REPAIR AND UPGRADE CENTRAL PLANT, BLDG. 24

QUESTIONS AND ANSWERS

PROJECT NO. **E-24-320**

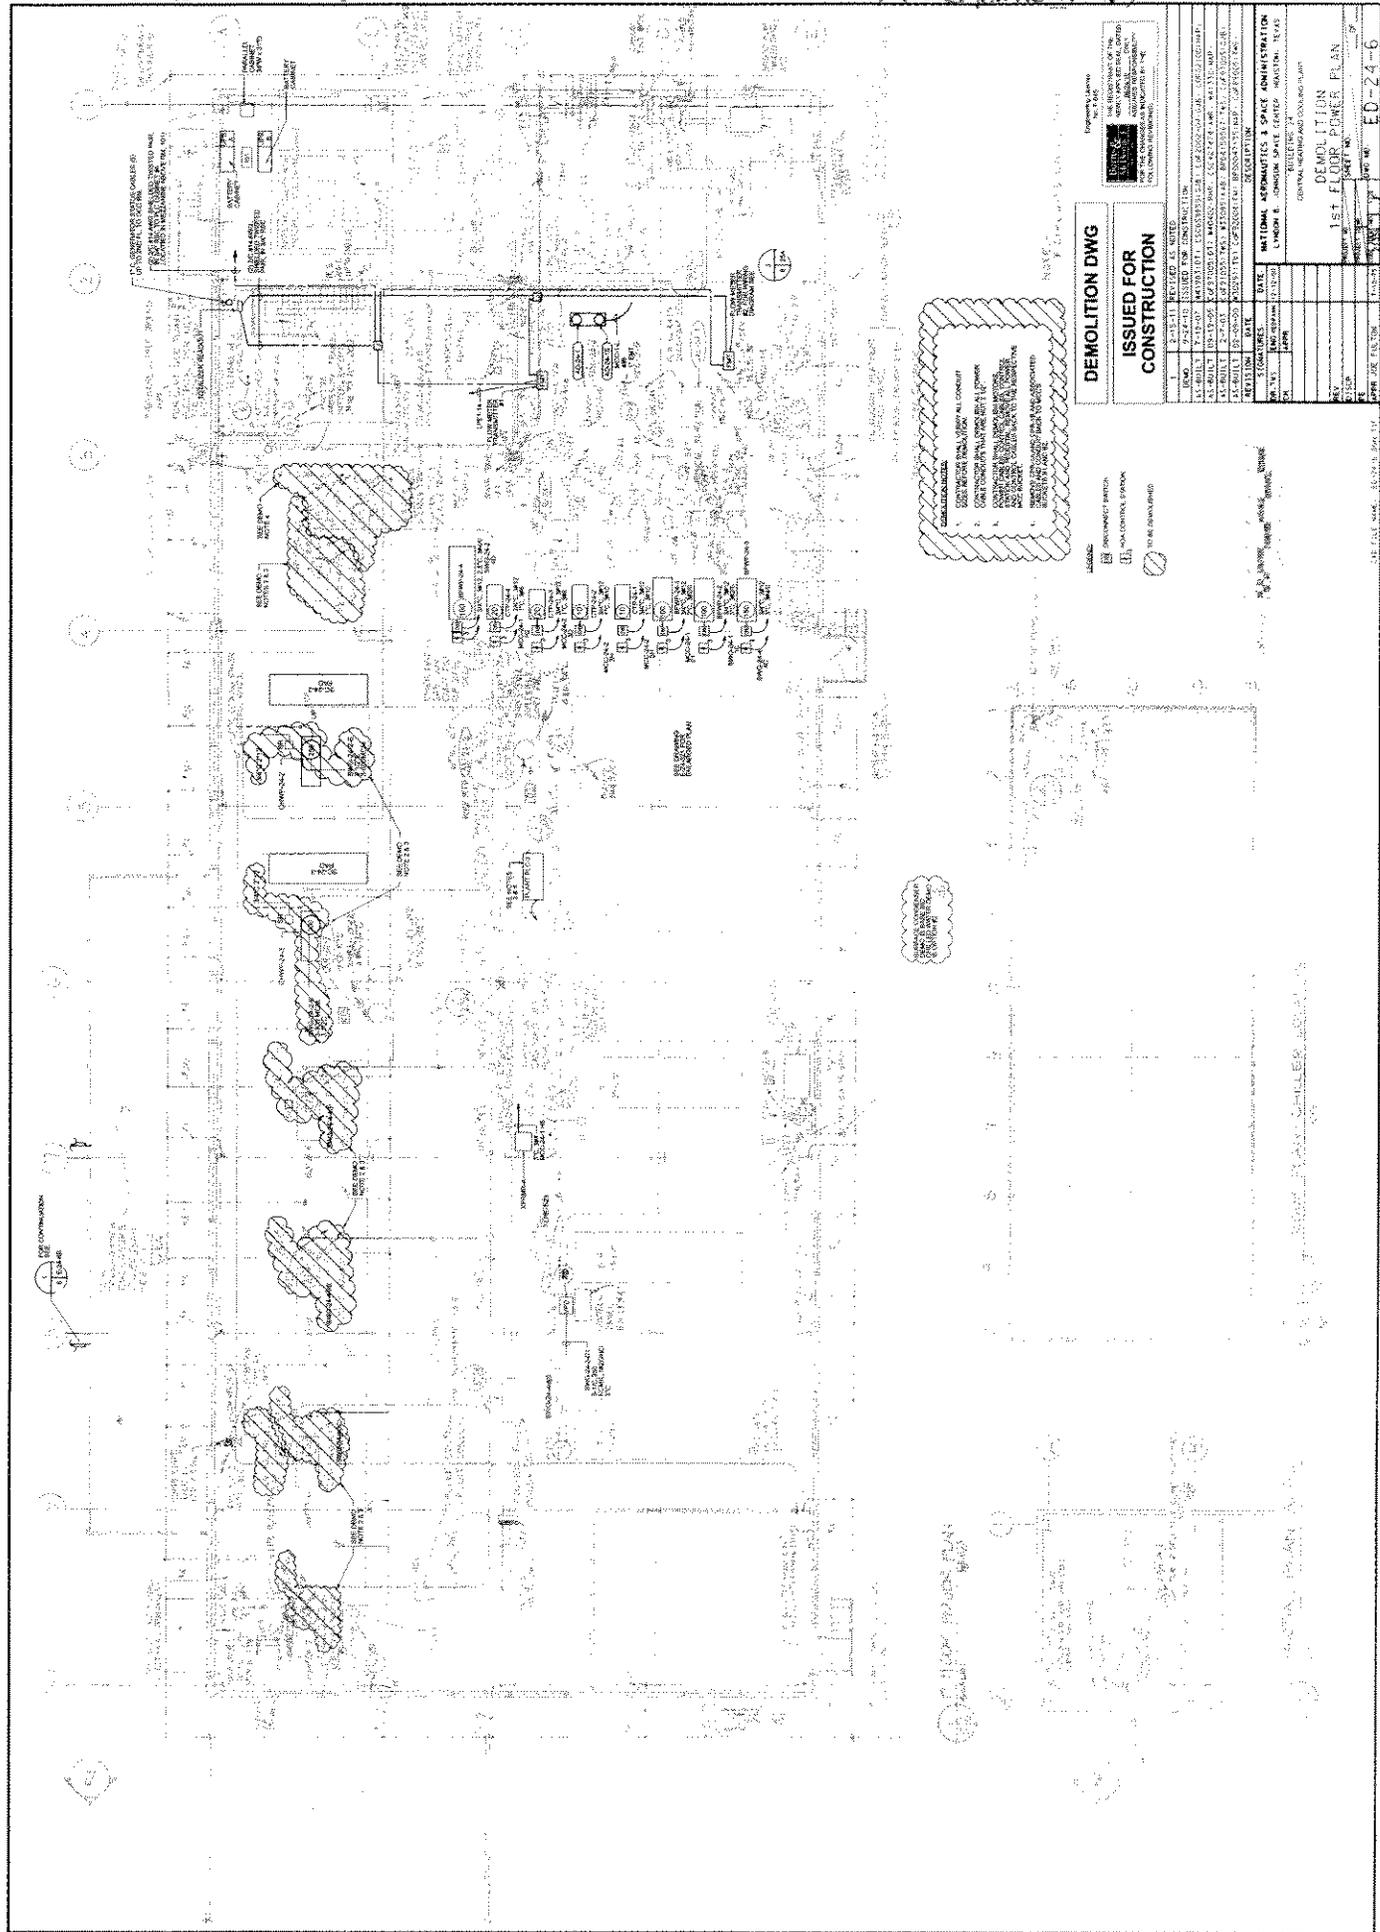
Question 245: Drawing E-24-320

Answer 245: X-FRMR-A and PP-A do not exist and are not required however the feeders are required. Drawing E-24-320 has been deleted and superseded by copies of E-24-6 and E-24-301, updated accordingly via this amendment. (See attachments 10g, 10i and 10k)
